Response to Consultation on Intra-Basin Transfers

Appendix A

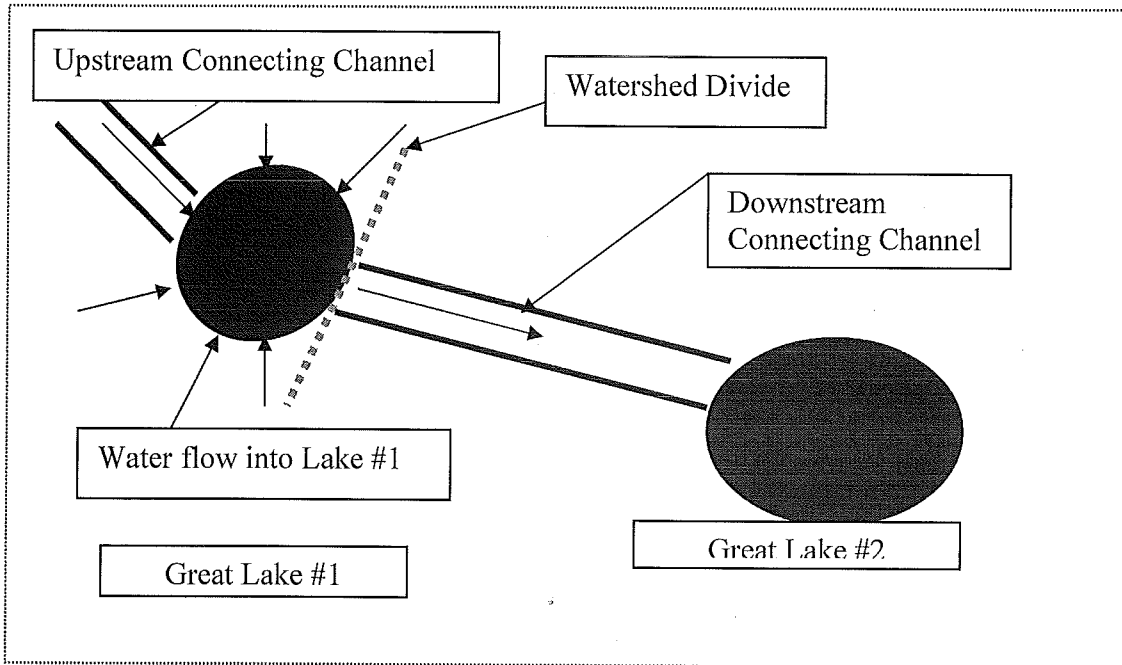
Consider the schematic of water flow between two lakes (Appendix A):

The first schematic demonstrates that all water in the watershed is flowing into Lake #1 - except the water in the downstream connecting channel which is flowing toward Lake #2

The hydrology of the system is even more evident when we change the schematic from top view to side (elevation) view. When water enters that downstream connecting channel it is lost to the source Great Lake.
